Record of Executive Business and Chief Executive's Order

PR/1428/21

Reg. Reference: SDZ21A/0014

Proposed Development:

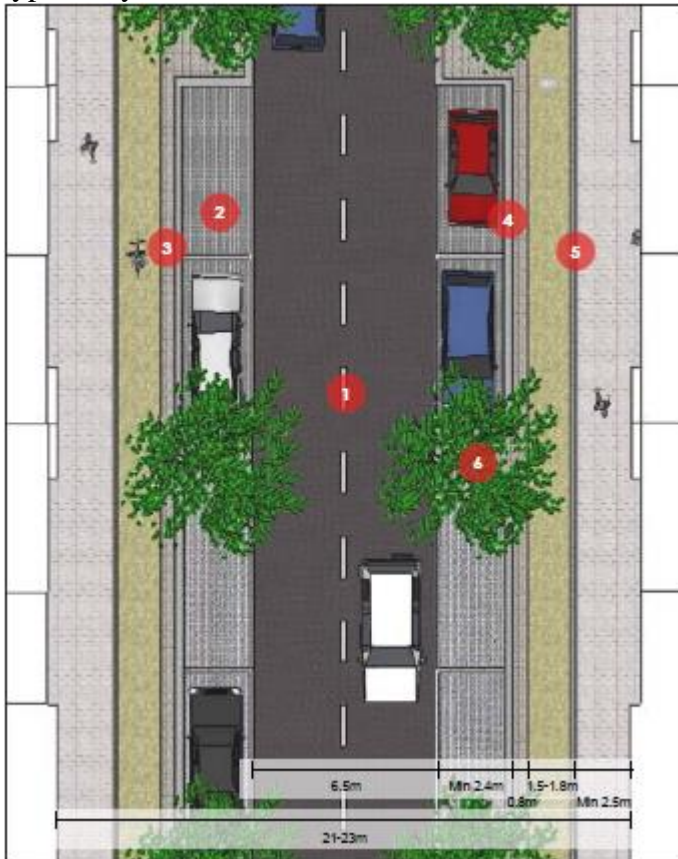
In relation to item 1(1), The Roads Department has stated: *“The applicant has not demonstrated adequate reason for the provision of parking spaces on the ‘Linear Park Road’ that has been identified in the planning scheme as an ‘Avenue’. Roads are not satisfied with the submission”*.

For 1(2), The Roads Department has stated that the department is *“satisfied with 2 (a) and (b). Roads department are not satisfied with 2 (c). The off-curtilage parking spaces cannot be placed on curtilage outside dwellings”*.
